**Re: Project, Permit No. M-1980-244;
Stormwater Preliminary Adequacy Review, Amendment Application (AM-13)**

The Division of Reclamation, Mining and Safety (Division) has completed its preliminary adequacy review (PAR) of your Cresson Project 112d-3 Reclamation Permit Amendment Application (AM-13), Volume III, Appendix 3 “Stormwater Management Plan (SWMP) and Valley Leach Facility (VLF)/Overburden Storage Area (OSA) Closure Stormwater Analysis Report”. The Division sent a Preliminary Adequacy Review (PAR) Letter for the all sections of the AM-13 Application (except this stormwater section) on April 3, 2020. The **decision date for the application** has been set to **May 31, 2020**.

Figure 4 Markup

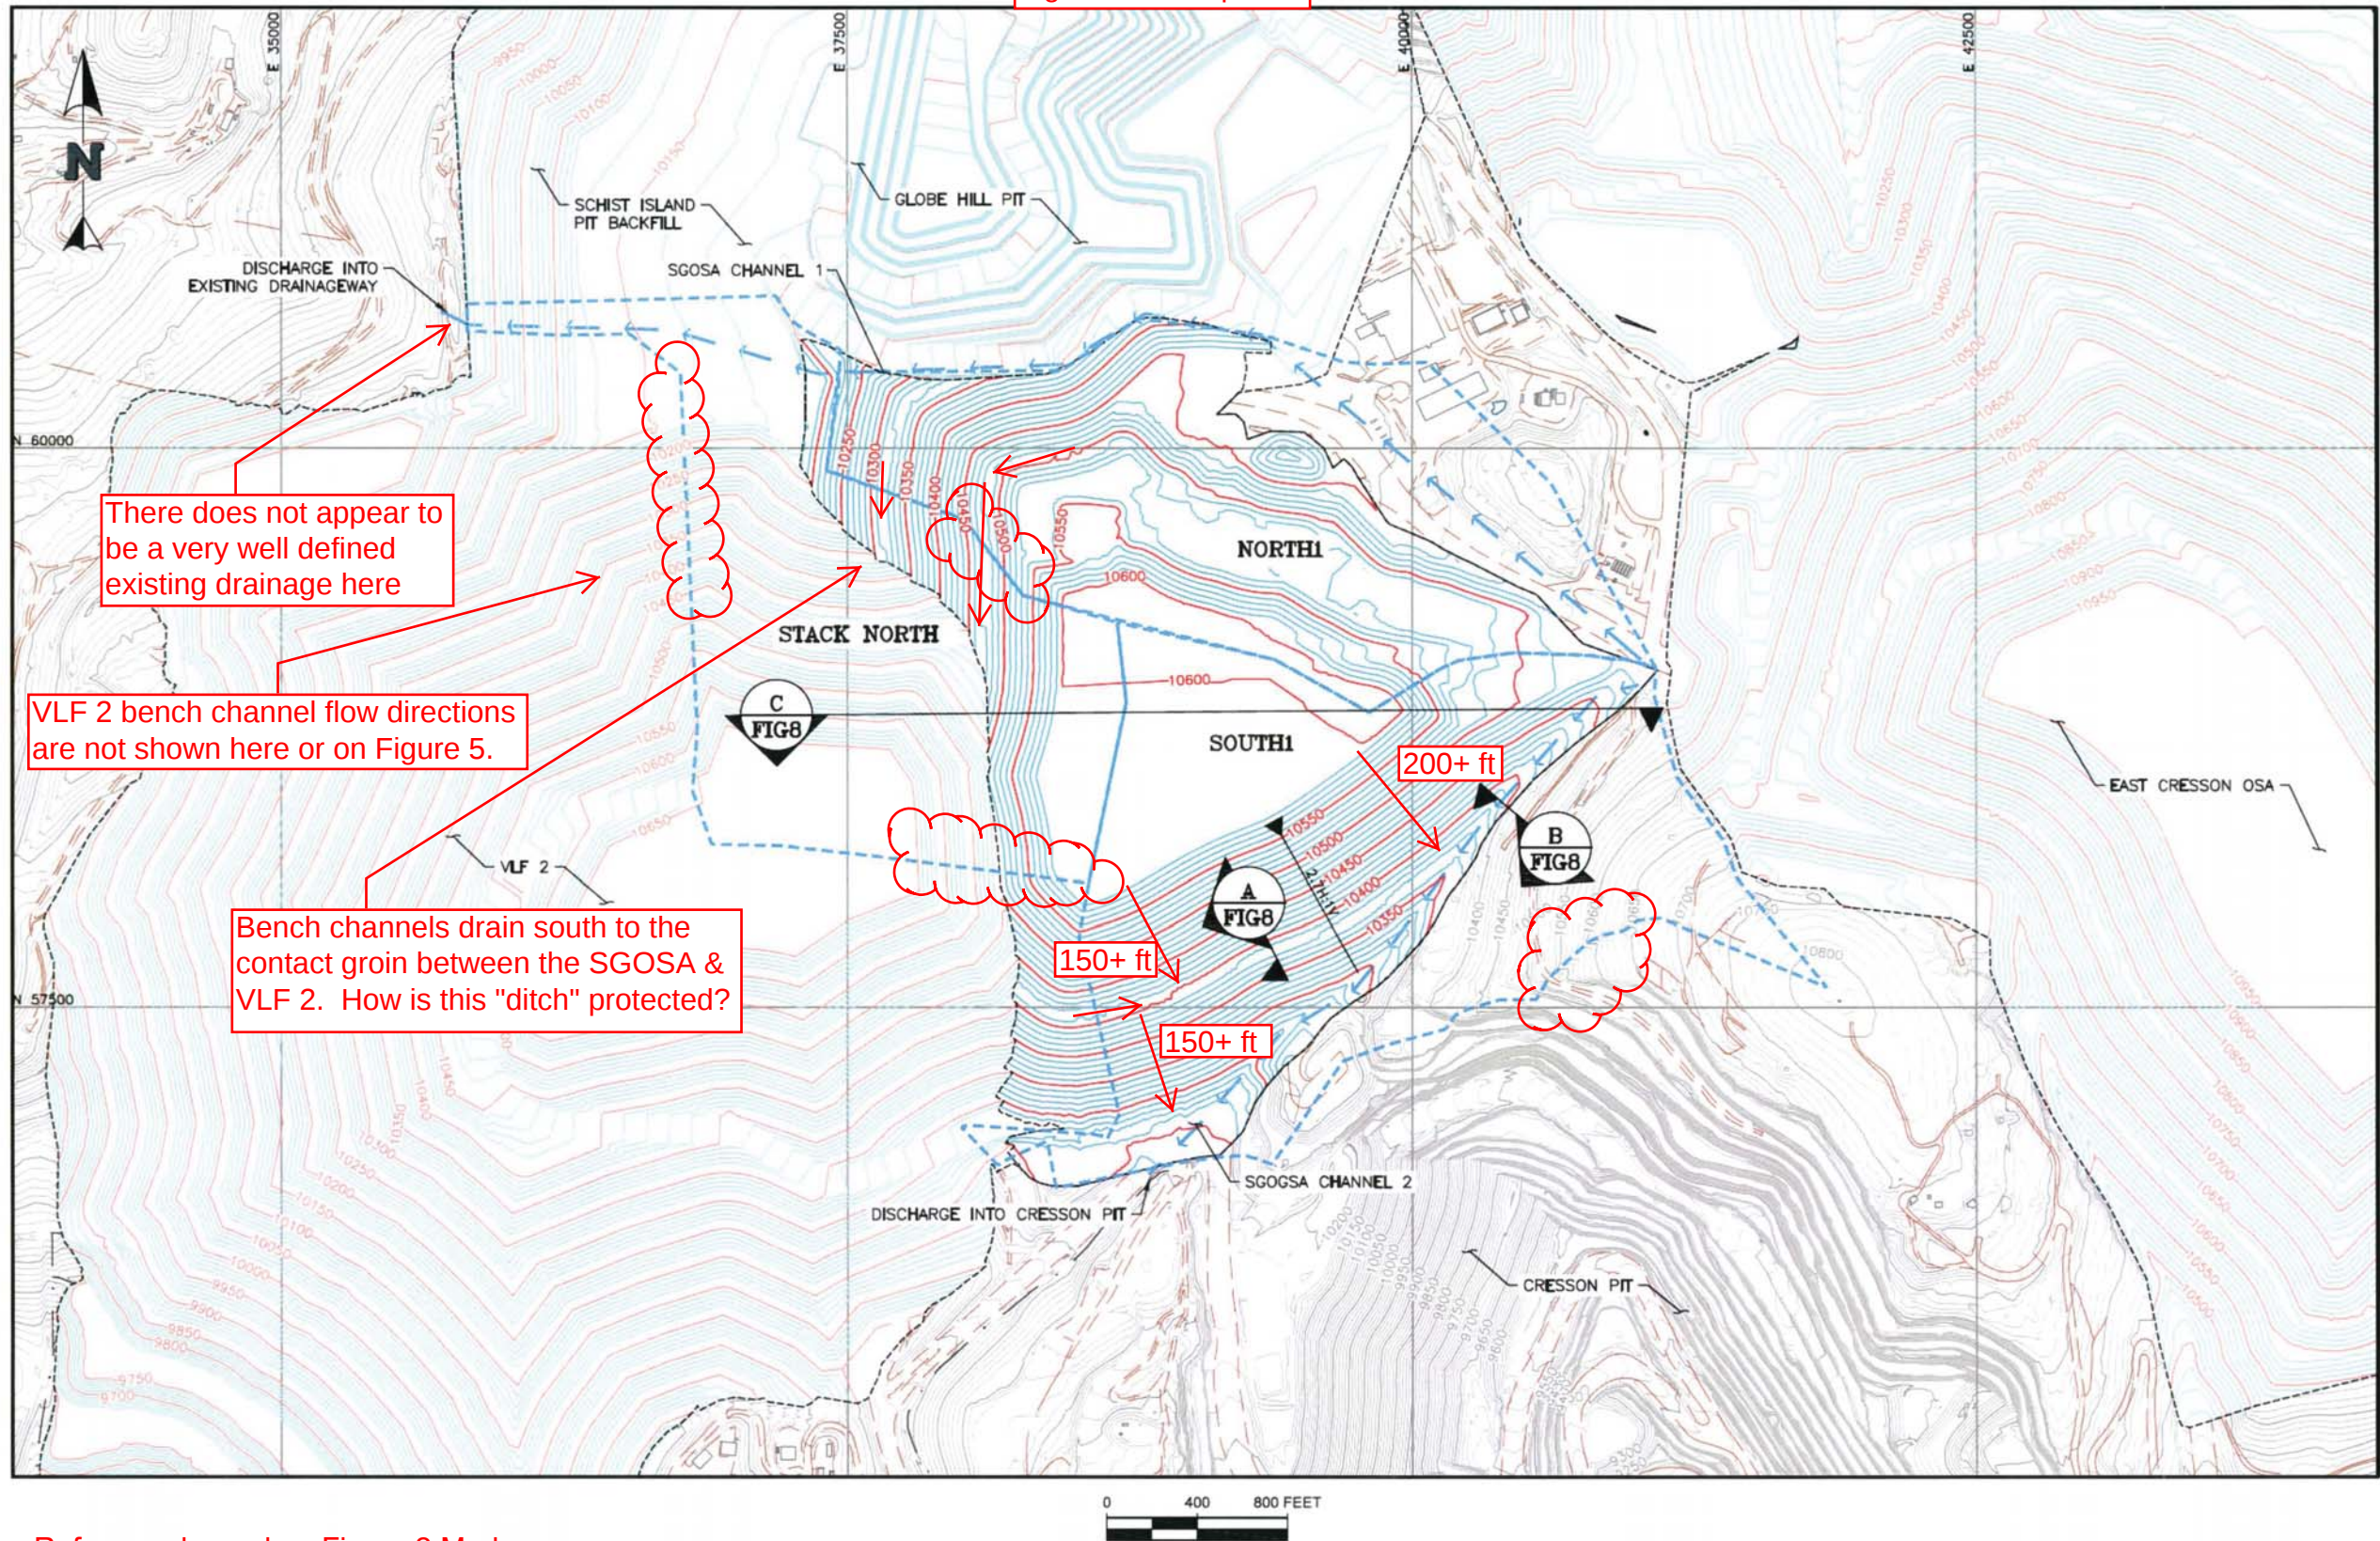
L. Figure 4. Please reference the enclosed Figure 4 Markup and address the following:

- a. Watershed delineation labels need to be added to the legend,
- b. Bench Channels should be corrected to be no more than 150 feet apart (vertically) and shown in grading plan,
- c. Watershed delineations are inconsistent with the grading plan,

- d. The steep contact channel on the north side of the contact between VLF 2 and the SGOSA does not appear to be designed, and
- e. The discharge to the existing drainage way on the west appears to be into swale rather than an incised drainage. This will likely lead to significant head cutting. How will head cutting be avoided?

Figure 5 Markup

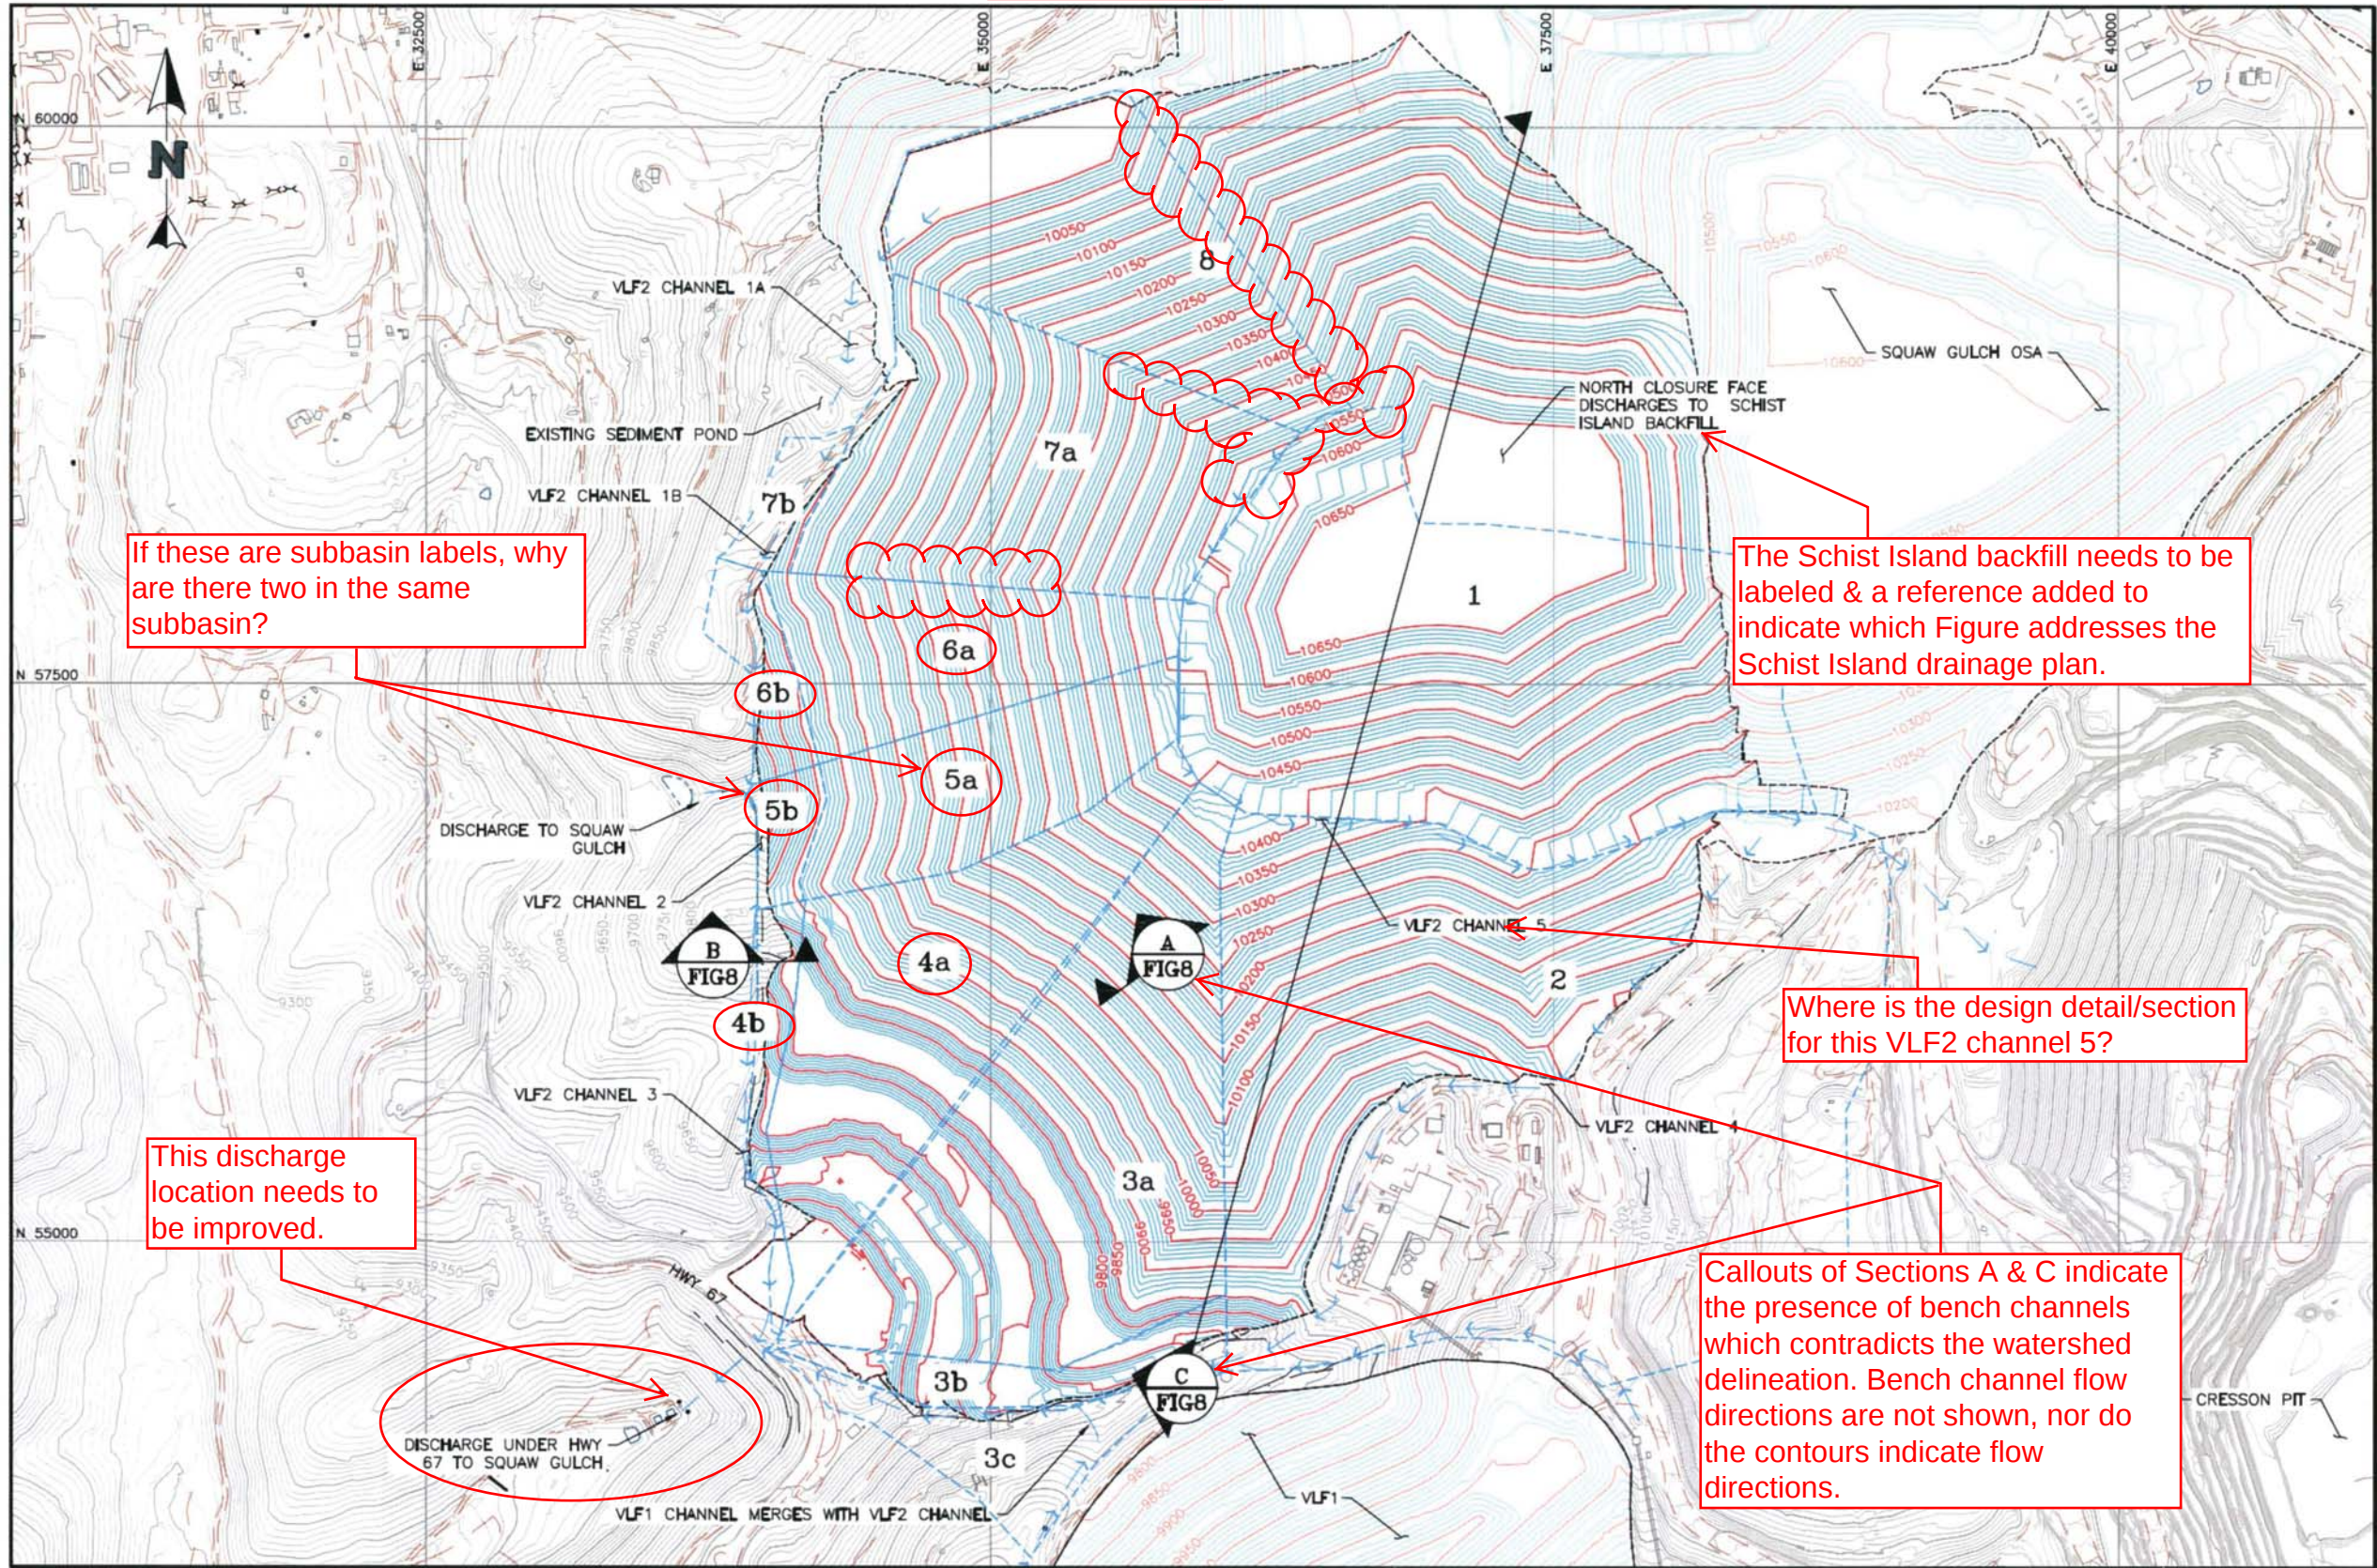
M. Figure 5. Please reference the enclosed Figure 5 Markup and address the following:

- a. Watershed delineation labels need to be added to the legend,
- b. Watershed delineations appear to be inconsistent with the grading plan,
- c. There is no design detail/section for the haul road channel (VLF2 channel 5),
- d. Bench channel flow directions need to be shown.
- e. The ultimate discharge location appears to be down the steep face of the VLF2/SGVLF toe berm on the SW side of Hwy 67. There is no defined or established drainage here. Some means of controlling discharge to the existing Squaw Gulch drainage needs to be presented that will not result in excessive scour.

If these are subbasin labels, why are there two in the same subbasin?

The Schist Island backfill needs to be labeled & a reference added to indicate which Figure addresses the Schist Island drainage plan.

Where is the design detail/section for this VLF2 channel 5?

This discharge location needs to be improved.

Callouts of Sections A & C indicate the presence of bench channels which contradicts the watershed delineation. Bench channel flow directions are not shown, nor do the contours indicate flow directions.
